## <u>ADDENDUM A</u>

Staff Report: Z-45-25-1 September 3, 2025

The purpose of this addendum is to revise the site plan, elevations, and landscape plan submitted by the applicant, which includes a building at the southeast corner of the site and additional landscaping.

This request is to rezone 0.53-acres located at the northwest corner of 24th Avenue and Lone Cactus Drive from R-5 DVAO (Multifamily Residence District, Deer Valley Airport Overlay District) to A-1 DVAO (Light Industrial District, Deer Valley Airport Overlay District) for materials and equipment storage for masonry (granite countertop) business.

L 2.0 Conceptual Landscape

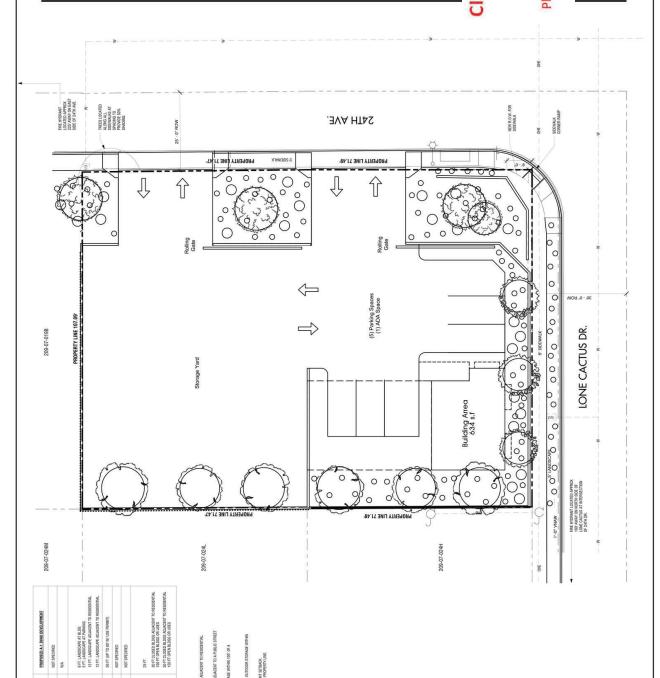
On August 18, 2025, the applicant submitted a revised site plan, elevations, and landscape plan. The revised site plan depicts an office building adjacent to Lone Cactus Drive. The elevations depict the height of the building as fifteen feet and four inches tall, made of stucco and stacked stone with a shade canopy. The landscape plan shows the proposed landscaping along 24th Avenue, Lone Cactus Drive, and along the west property line.
